FINAL DRAFT MINUTES

December 18, 2014 Standards Committee Meeting

RE: Minutes from the December 18, 2014 Standards Committee Meeting

PROPOSED NEW 808-DLIM-01 (REVISED DRAFT)

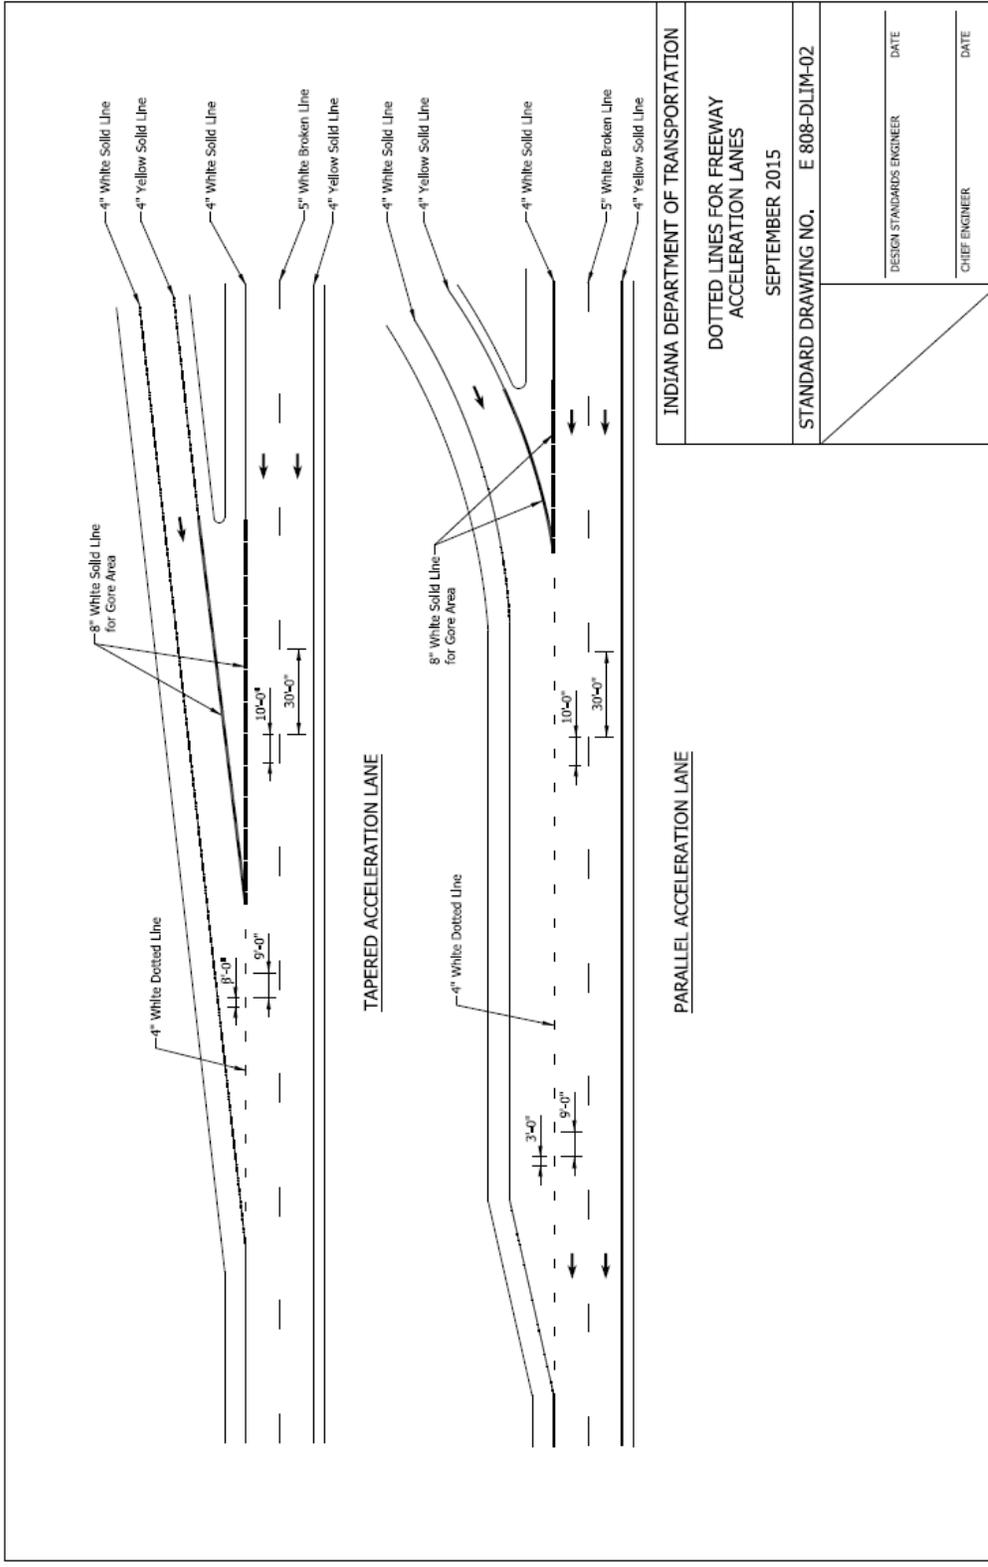
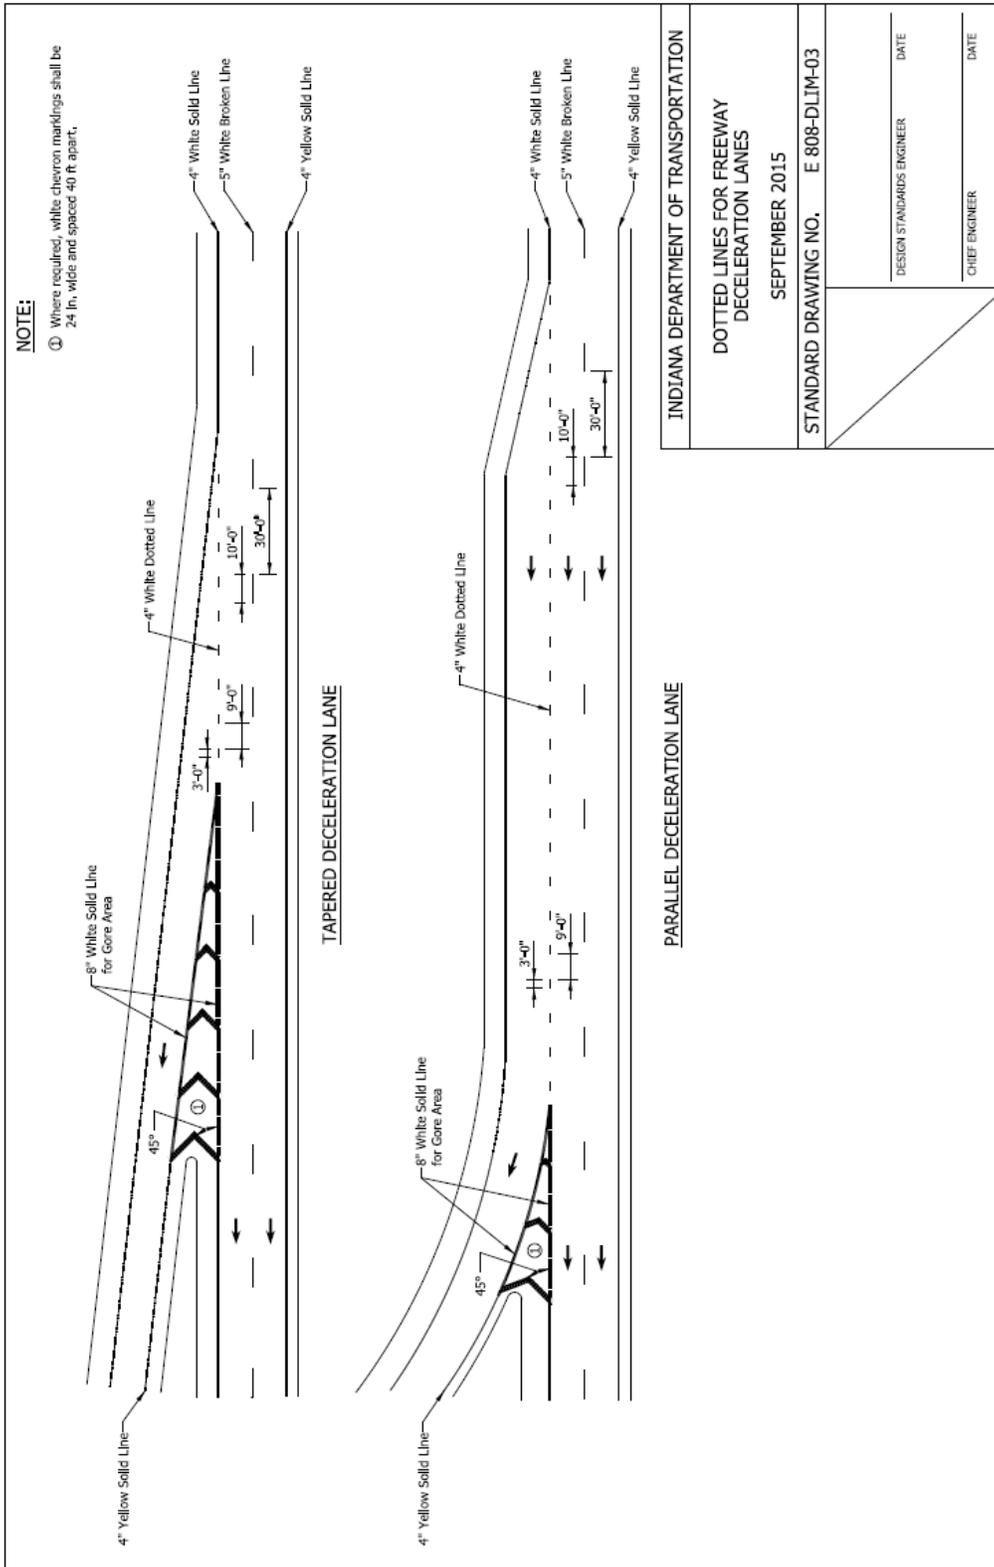
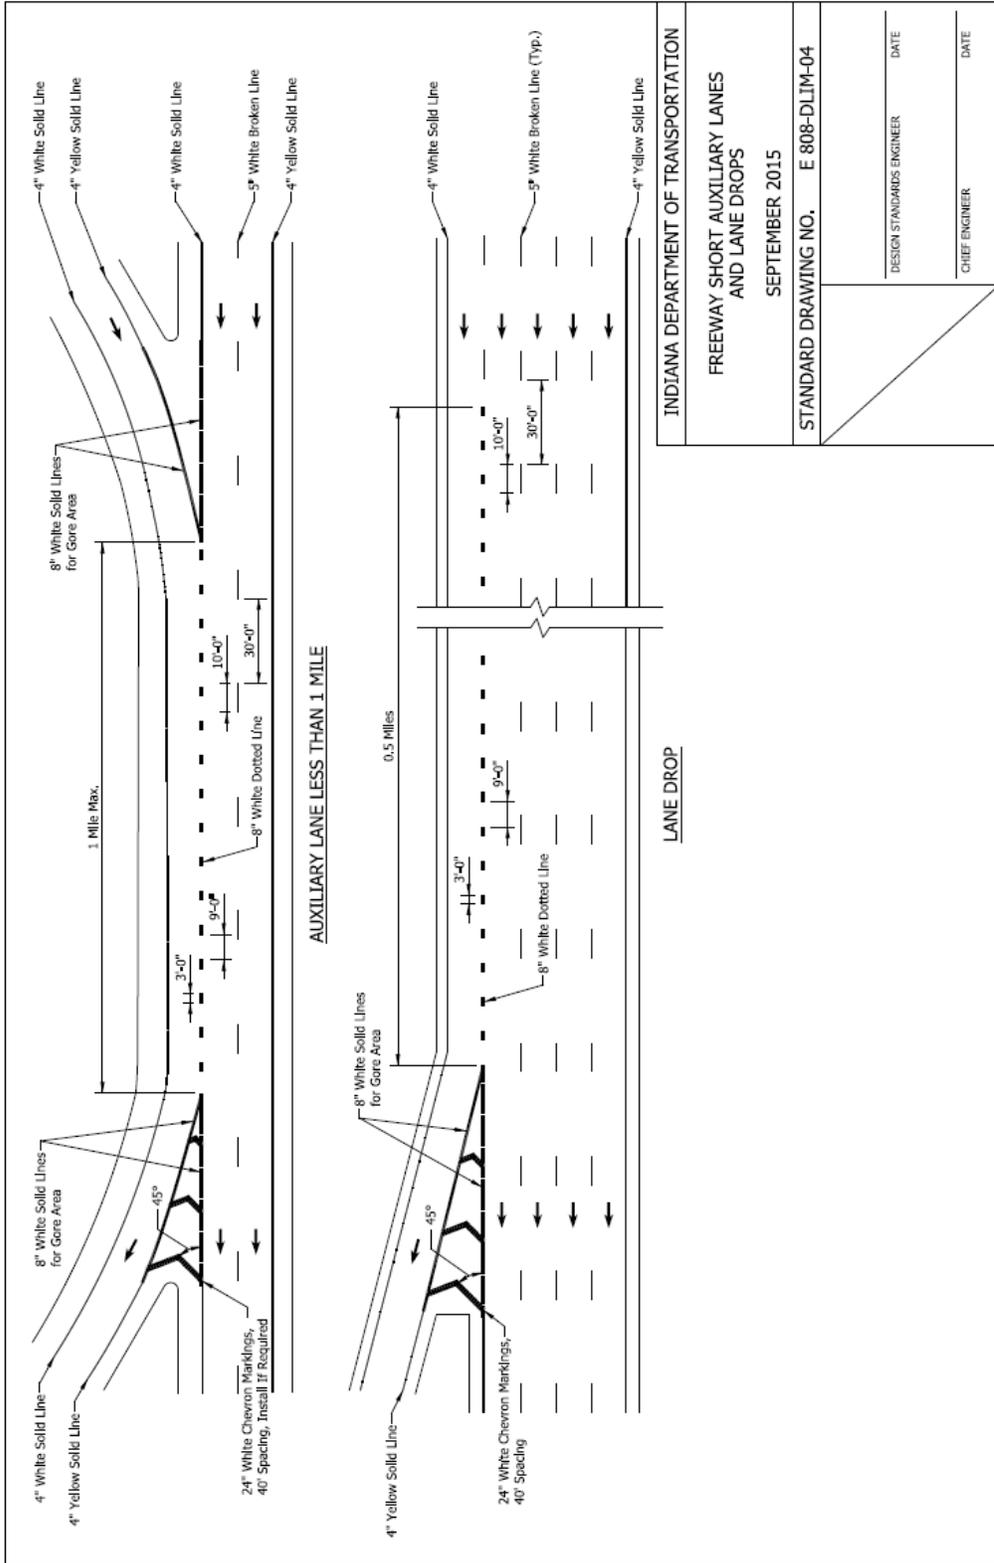
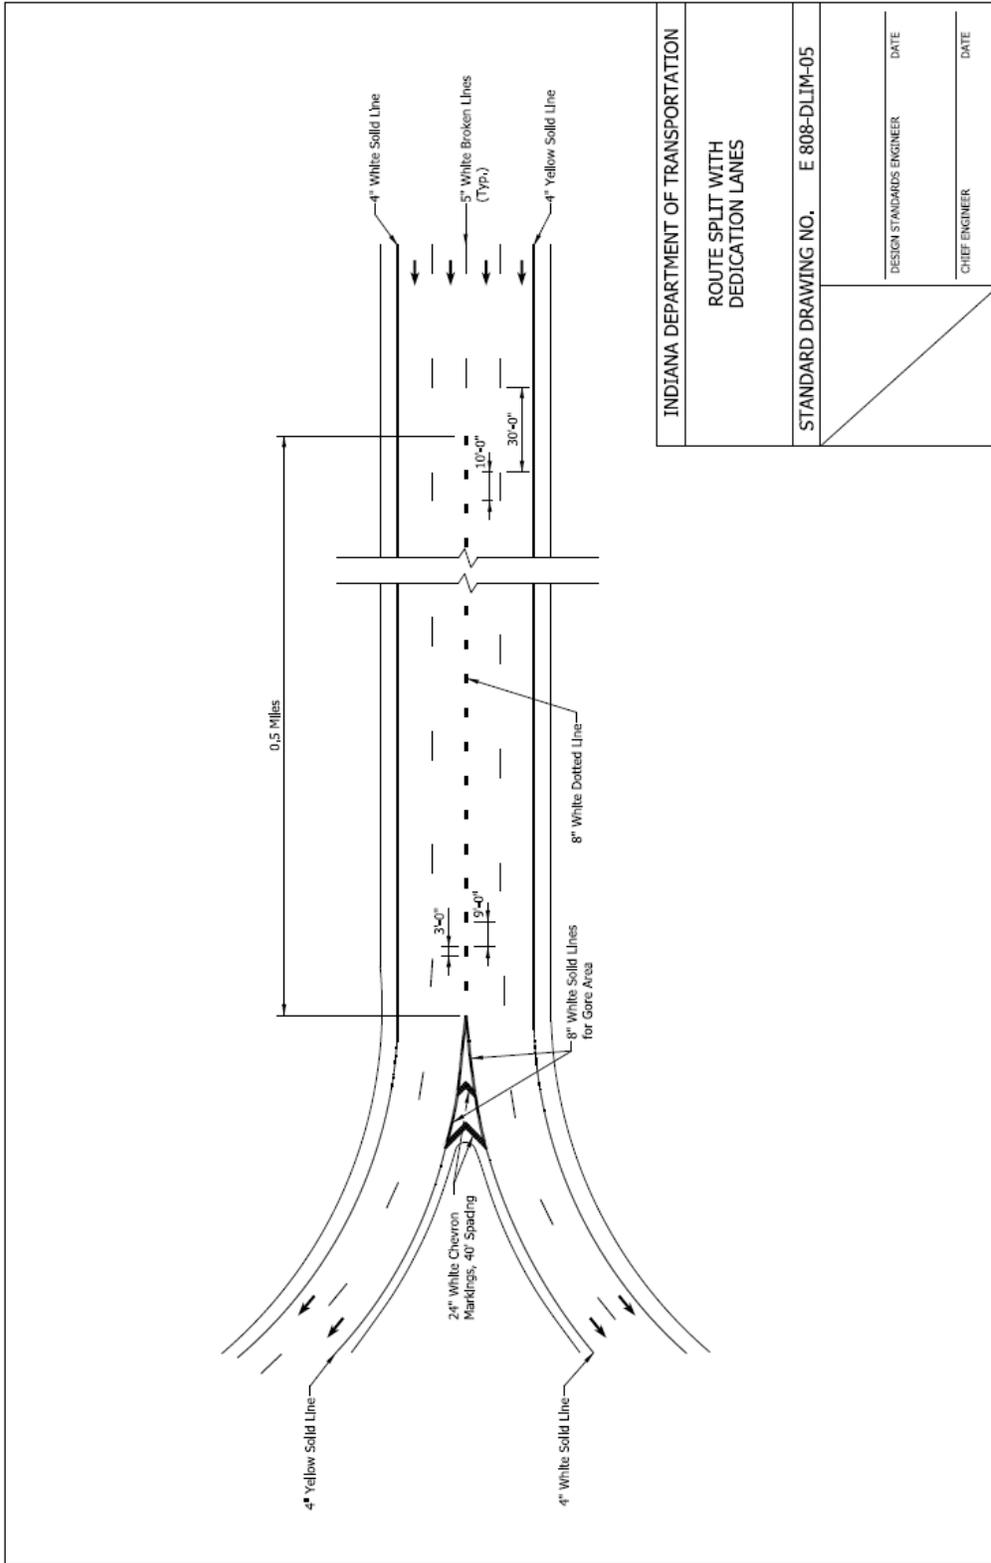
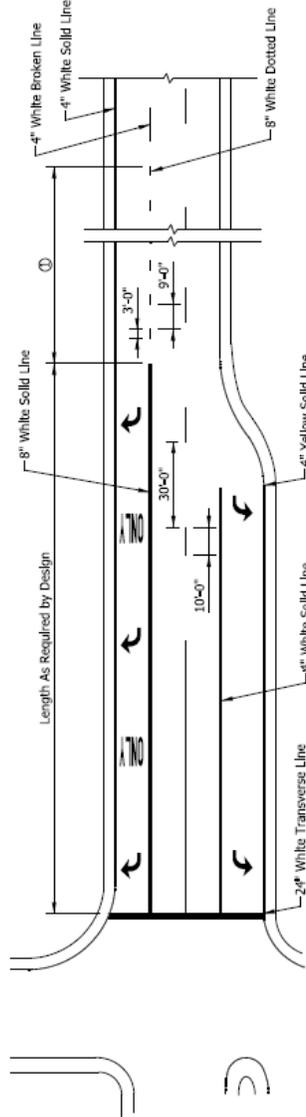
Mr. Bruno introduced and presented this item explaining the need to incorporate language pertaining to dotted lane lines into the Standard Specifications and Standard Drawings as required by the MUTCD. Mr. Bruno explained the revisions to drawings as shown. Mr. Bruno handed out additional revisions to some drawings as a result of industry input. Approved revisions shown as *revised draft* in these minutes.

Ms. Phillips asked about the chevrons shown, and Mr. Bruno said that they are optional and up to the designer. Ms. Phillips expressed that if it is shown on the standard drawing then it is assumed to be required. Should there be a note on the drawings stating that they are optional?

808-MKRM-08 RAISED PAVEMENT MARKERS TYPICAL LOCATIONS (WITH MARKUPS)

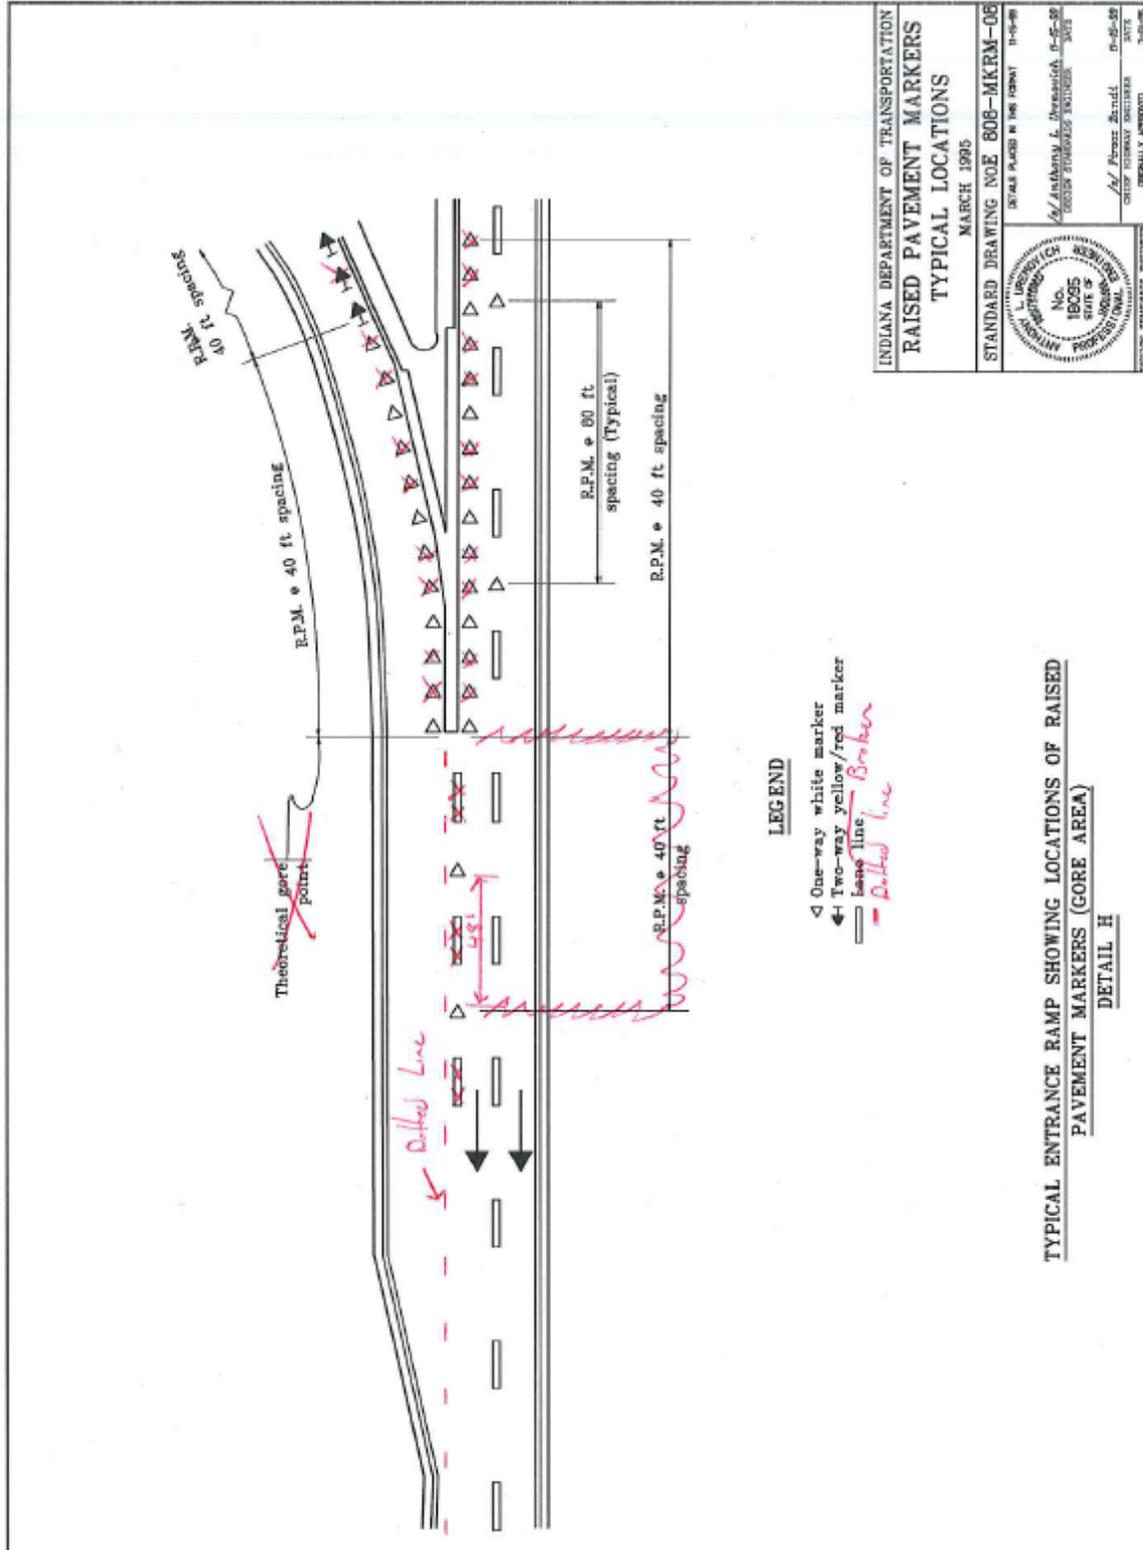
PROPOSED SOLUTION: Create 5 new standard drawings for dotted line interchange/intersection markings (DLIM) and revise the RPM spacing shown in the acceleration lane of Standard Drawing 808-MKRM-08.
